**Queen
Anne's
County**

Queen Anne's County
2011 Comprehensive Water and Sewerage Plan
Amendment No.11-10
November 22, 2016

Map Amendment

Prospect Bay Water Service Area

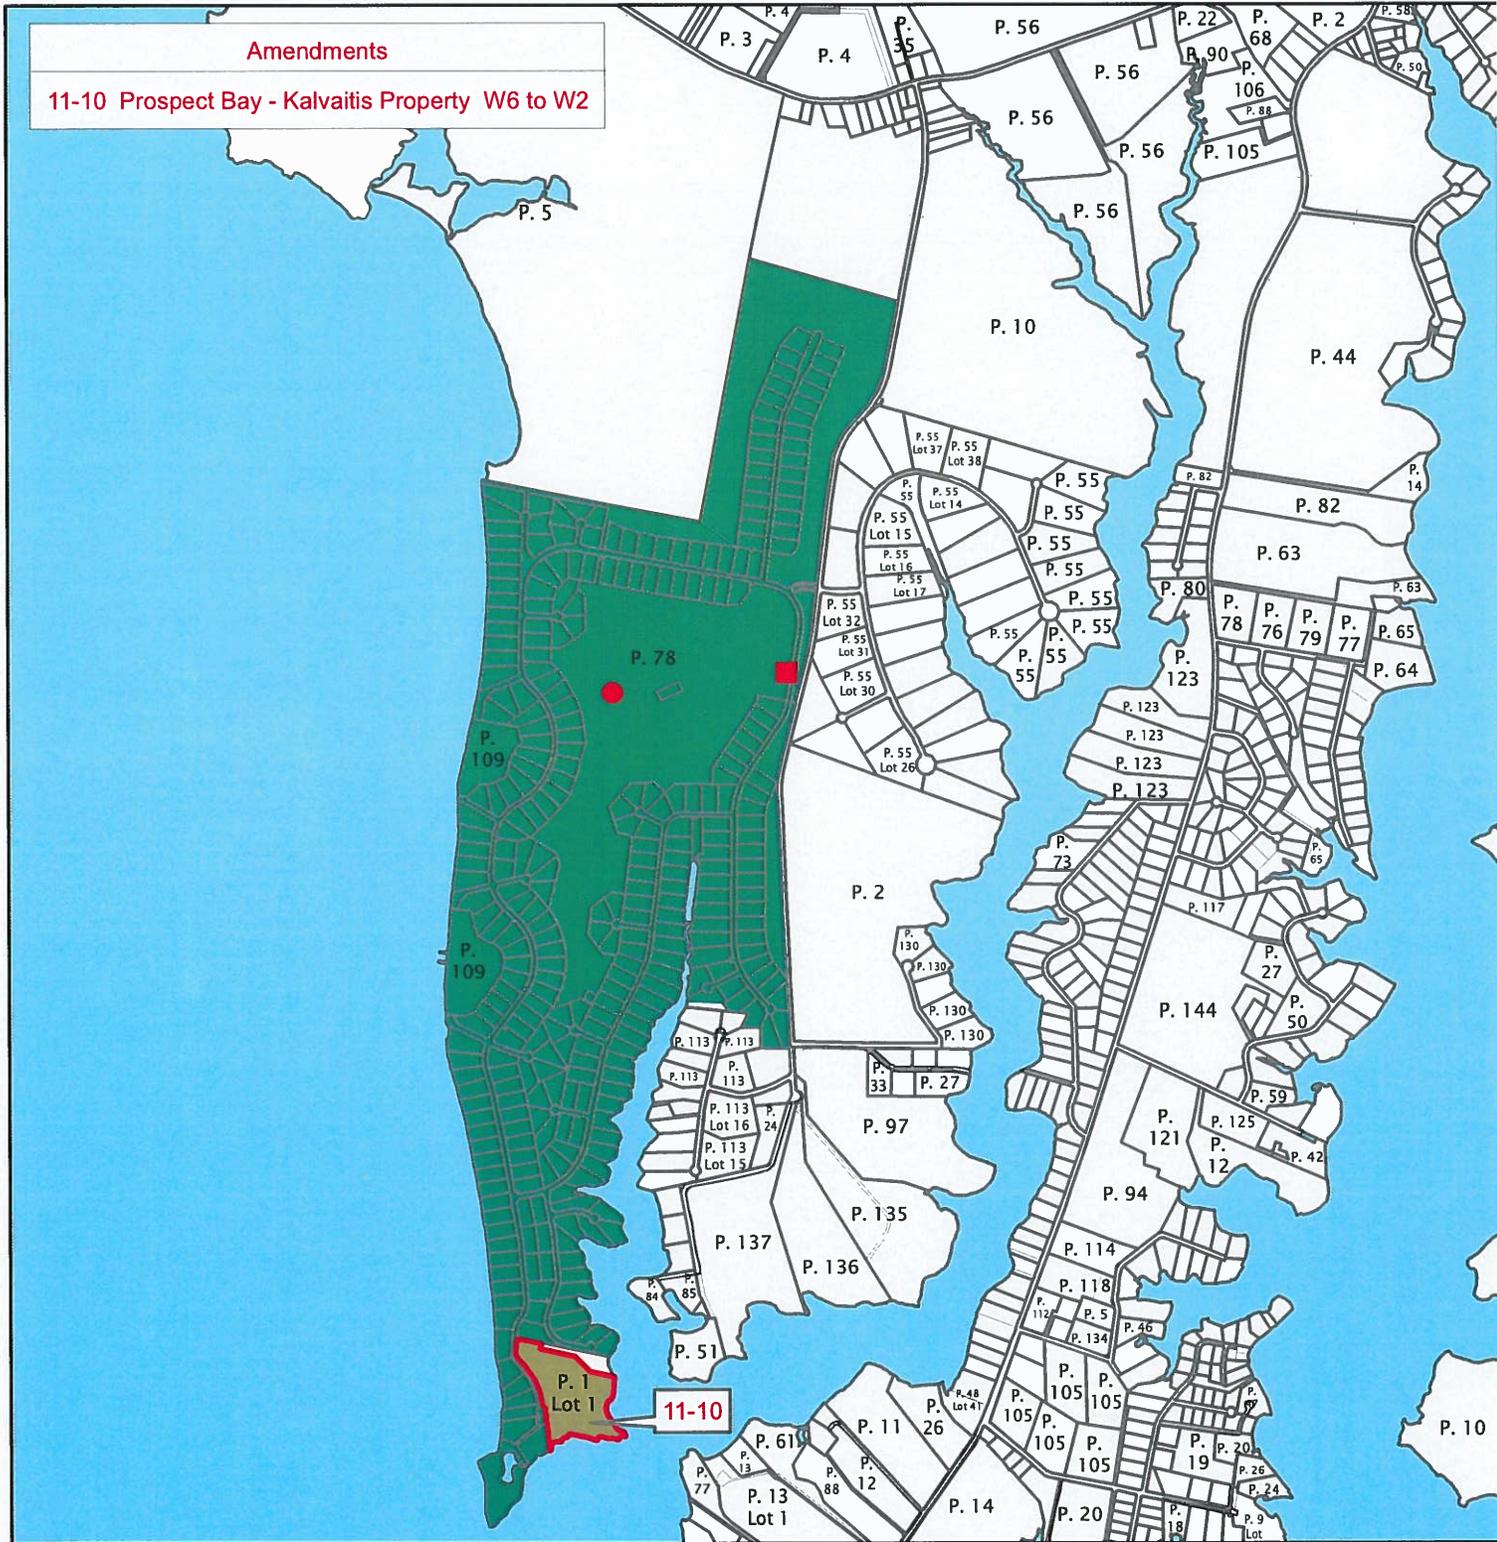
Prospect Bay Water Map - Upgrading water service designation of a single family home owned by Kalvaitis from W-6 to W-2. It is noted the existing well serving the property must be properly abandoned when no longer regularly used for irrigation. It is further noted that this amendment is to only allow the existing dwelling to connect to public water. Any further development on the property will require its own amendment.

Amendments
11-10 Prospect Bay - Kalvaitis Property W6 to W2
